PLAN 1

PLANNING APPLICATION PLN-20-0024

60 MALCOMBE STREET, LONGFORD

Additional Information Required for Planning Application PLN-20-0024 - Multiple Dwellings (6) – staged (vary setbacks/building envelope, north facing window & driveway separation to habitable rooms, parking forward of building line) at 60 Malcombe Street, Longford

Drawing: SITE PLAN

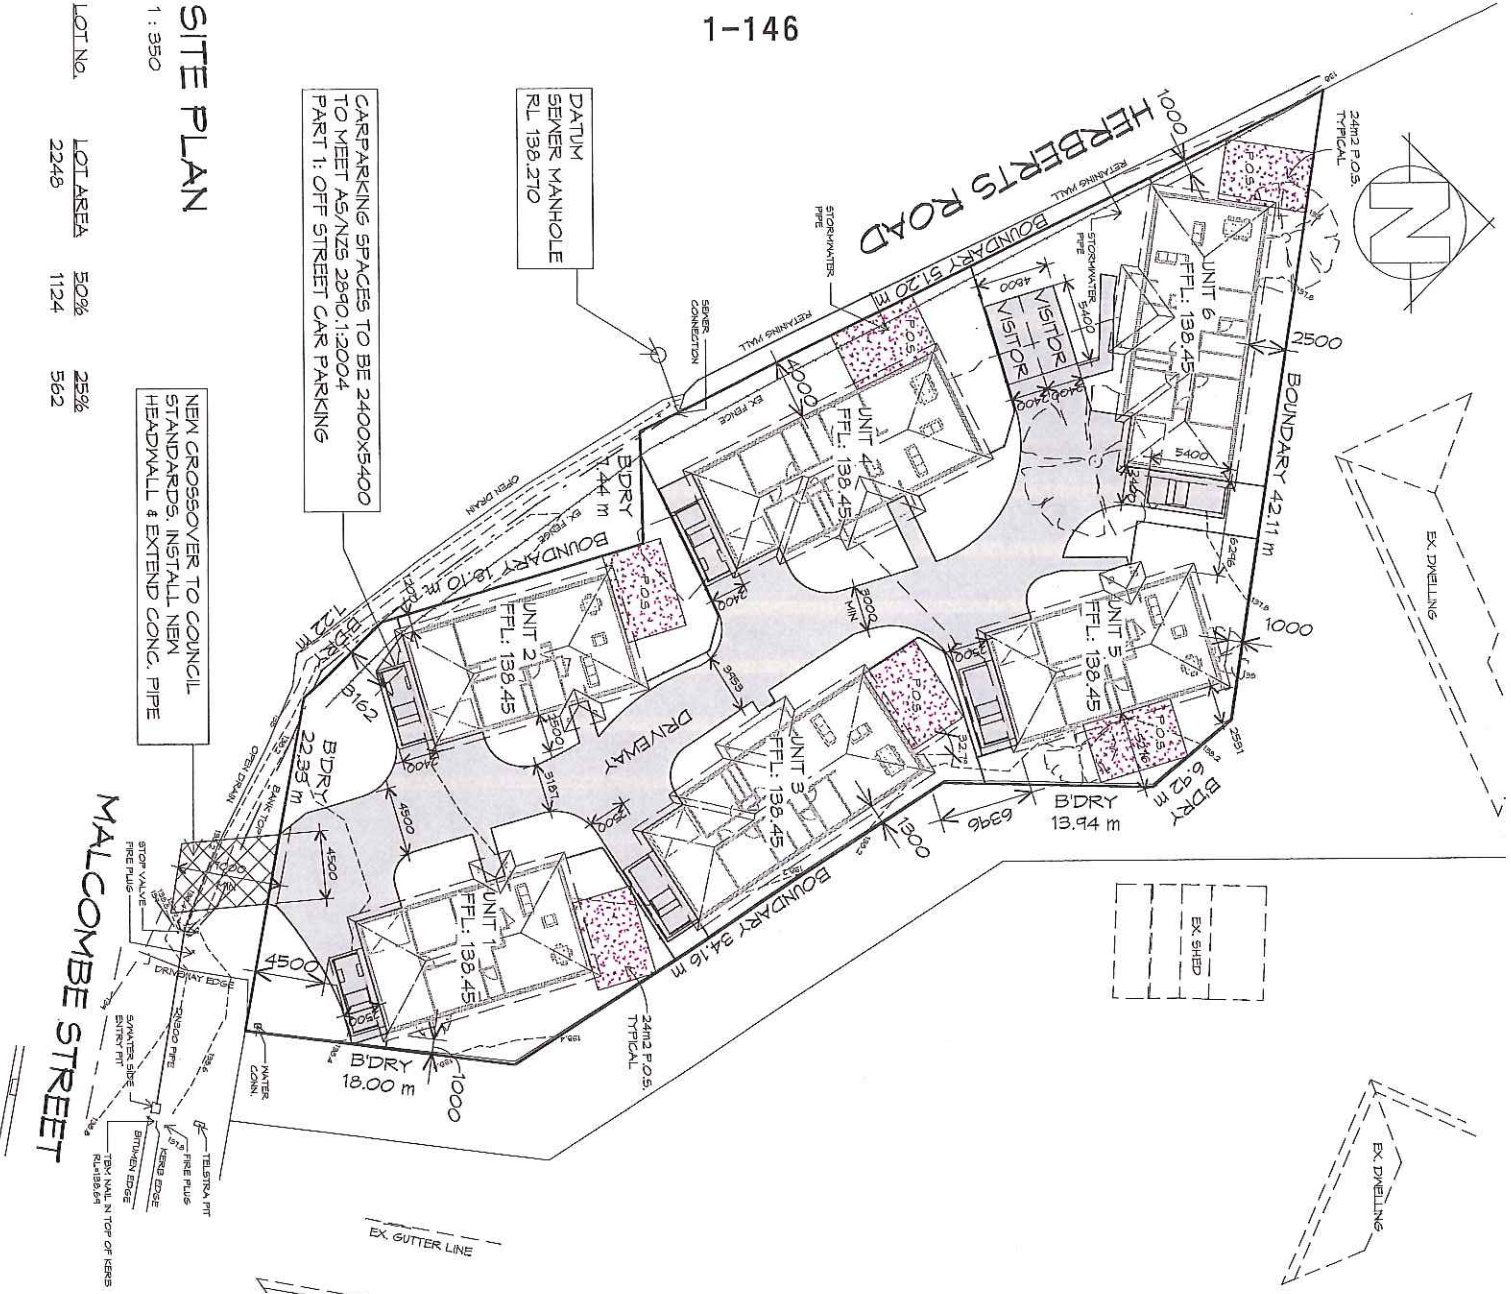
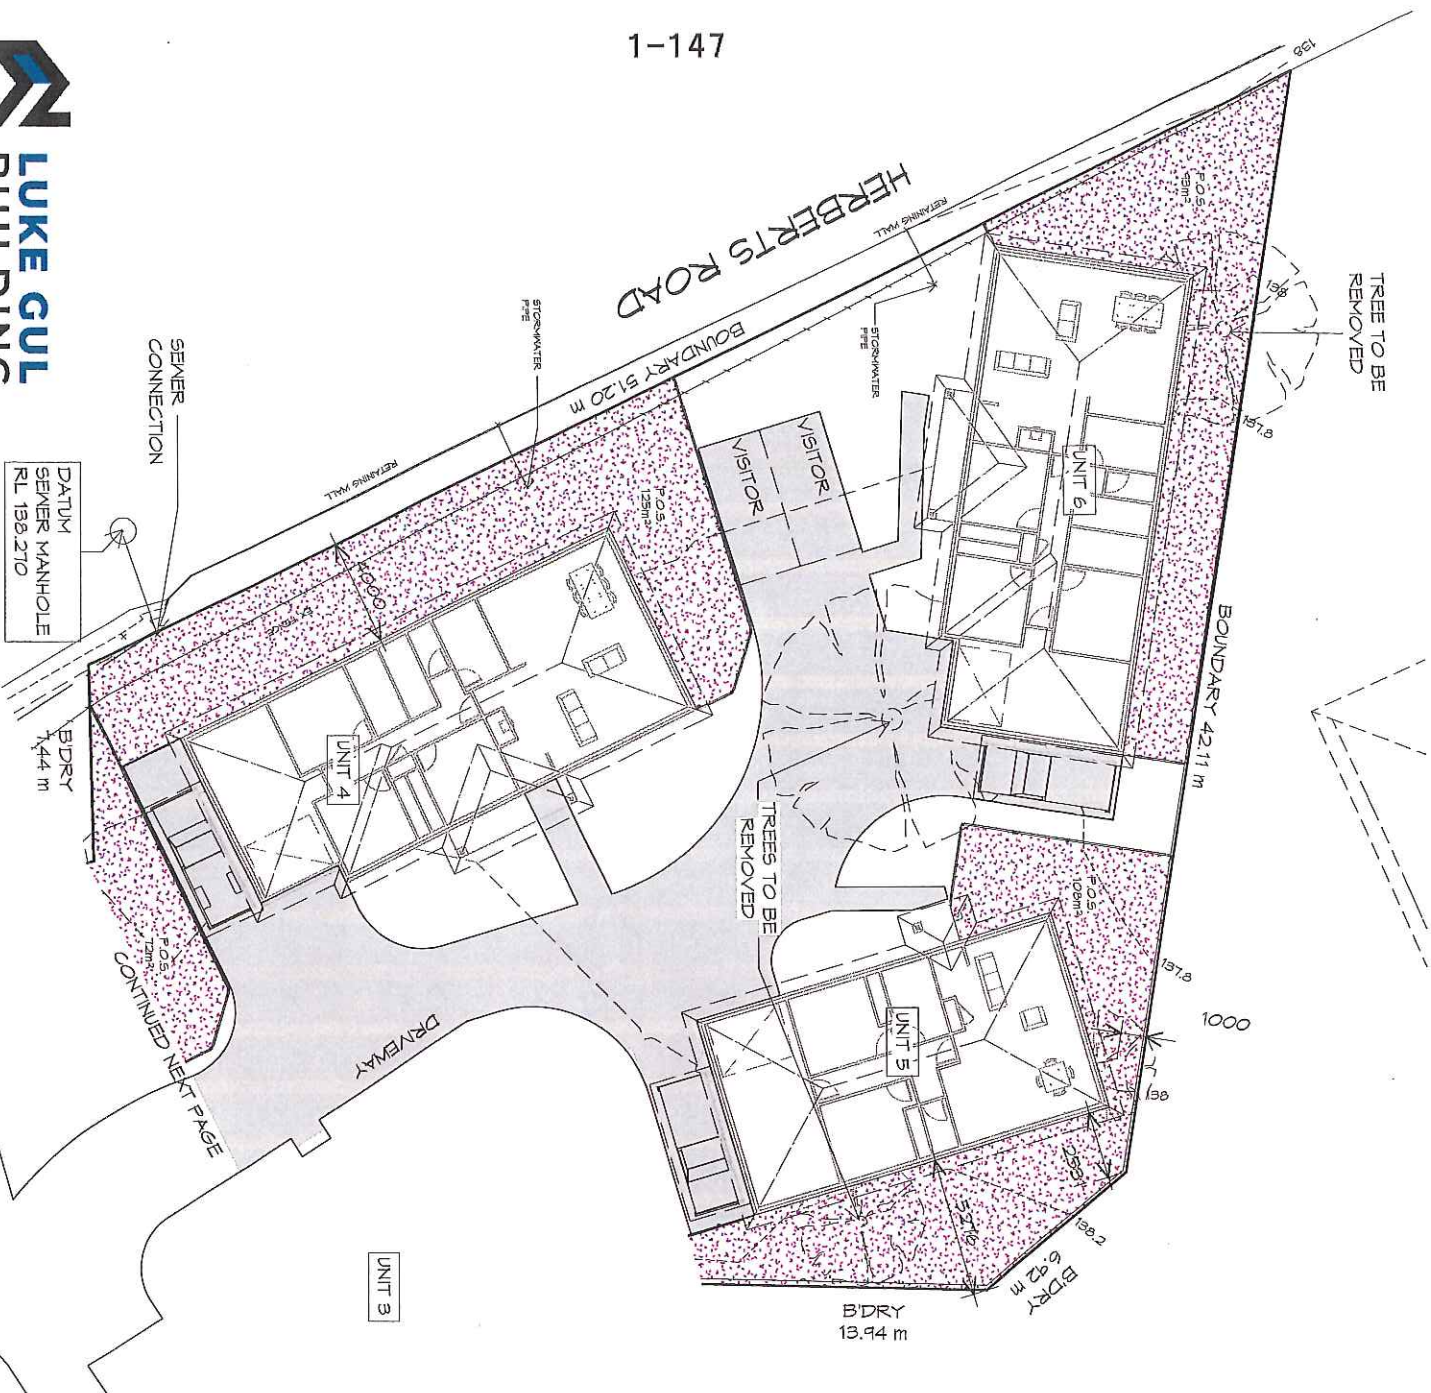
- Services plan
- Revised site plan showing parking space dimensions, minimum driveway widths & clotheslines removed from private open space.

PROJECT NAME	60 MALCOLME STREET DEVELOPMENT
DRAWING TITLE	STORMWATER SYSTEM OPTION 1 - GRAVITY SYSTEM
SCALE AT A3	DRAWING NUMBER 1:250 1885 - 001
SHEET	DISCIPLINE
1 OF 2	CI
REVISION	A

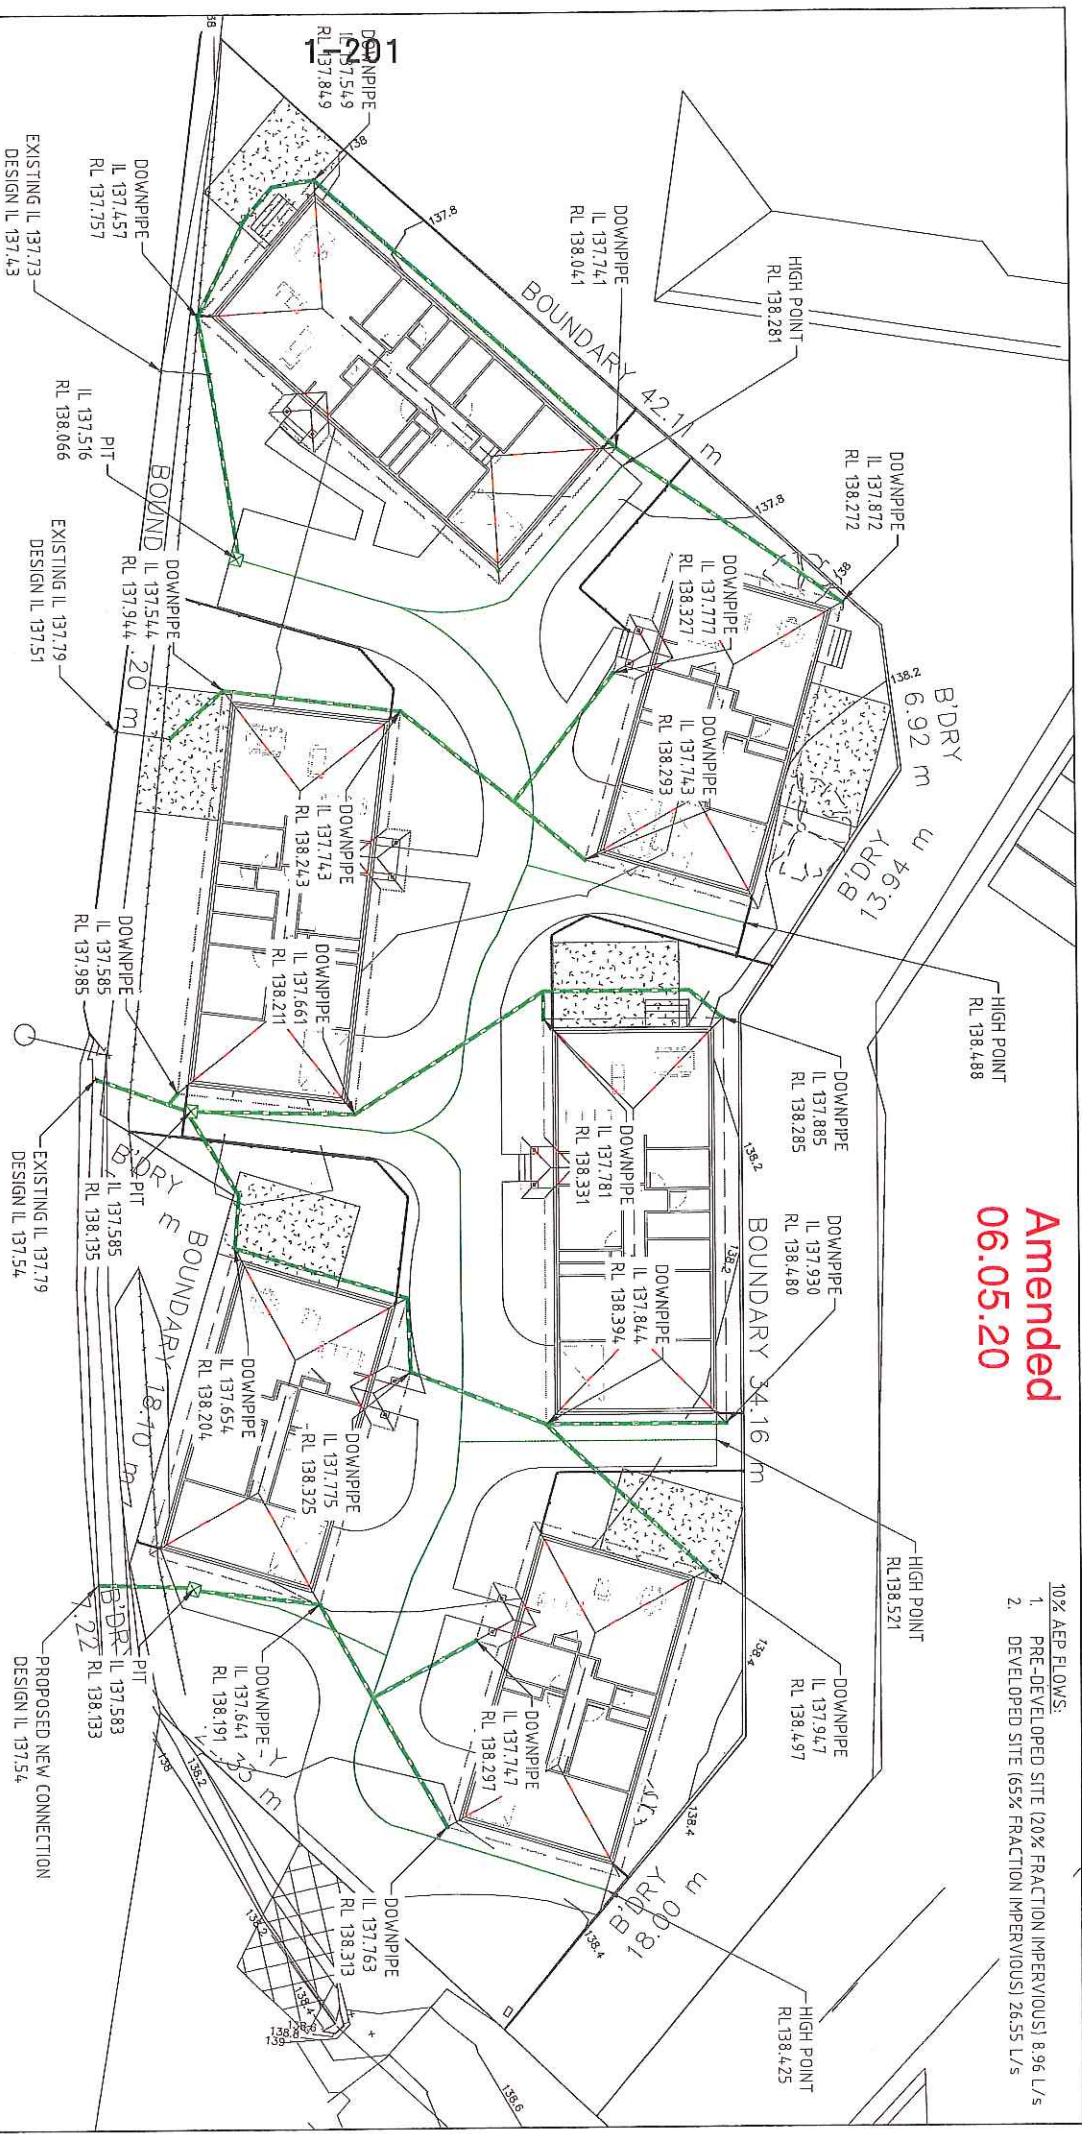
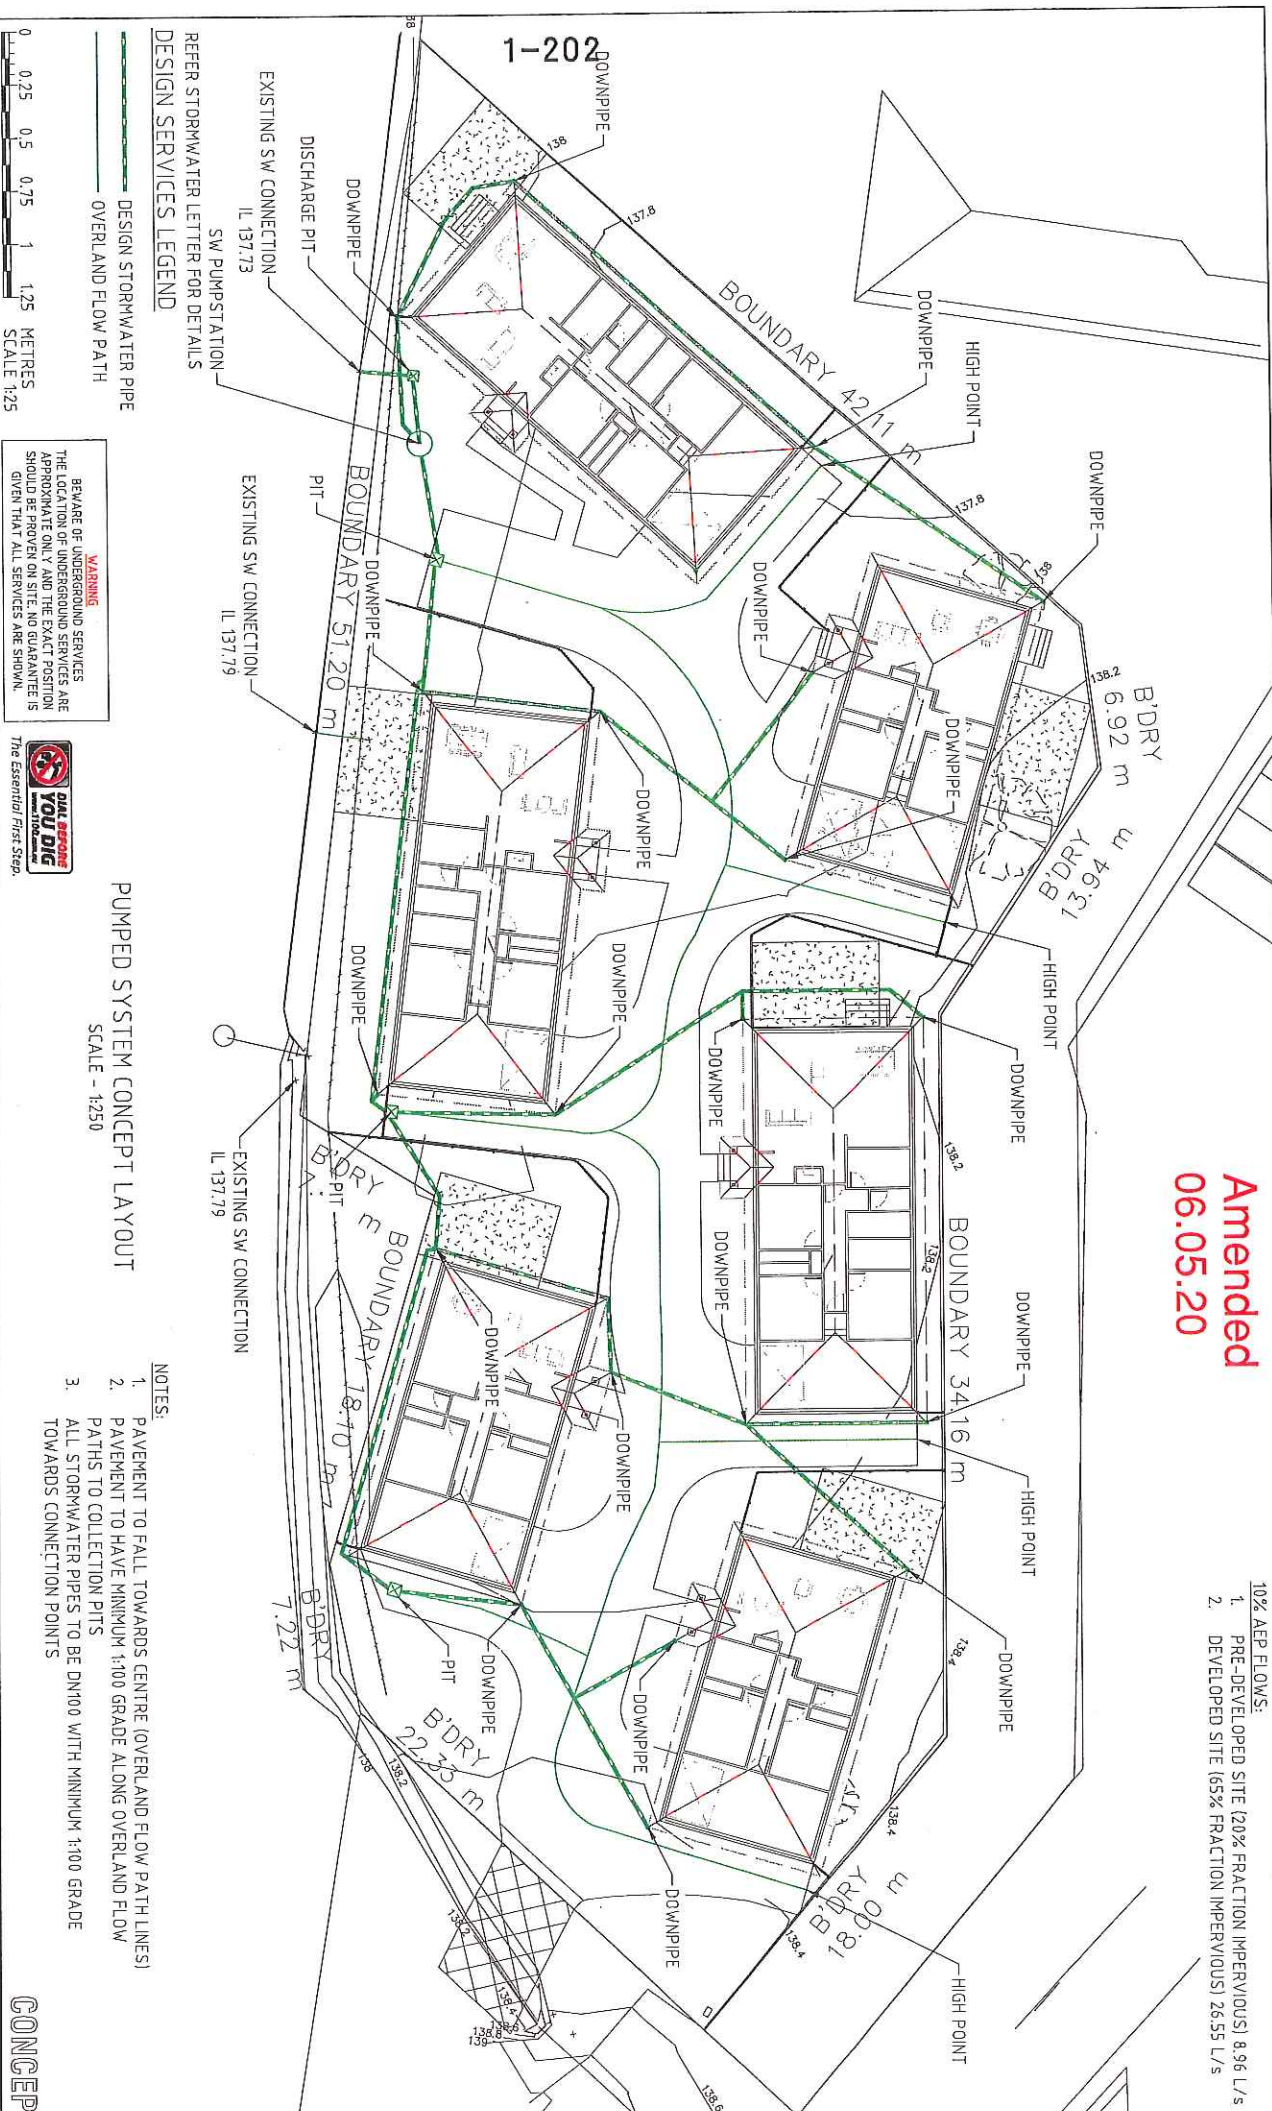
Thank you for the revised drawings and stormwater details – they have now been reviewed by Council's Works and Infrastructure Department, who have also taken levels on site, and who advise as follows:

Our onsite assessment suggests that it would be possible to drain the site without the need for a pump. Filling the site could create stormwater problems in neighbouring properties and is not recommended. There is an open drain along the western boundary and the stormwater connections shown on the plan come in partway up the side of the drain not into the invert (bottom). Please review the design with the connections lowered to the invert.

Accordingly, please provide a revised design with connections lowered to the invert, as per the above advice. In accordance with section 54 of the *Land Use Planning and Approvals Act 1993*, the statutory period for processing the application will not recommence until the requested information has been supplied to the satisfaction of the Planning Authority.
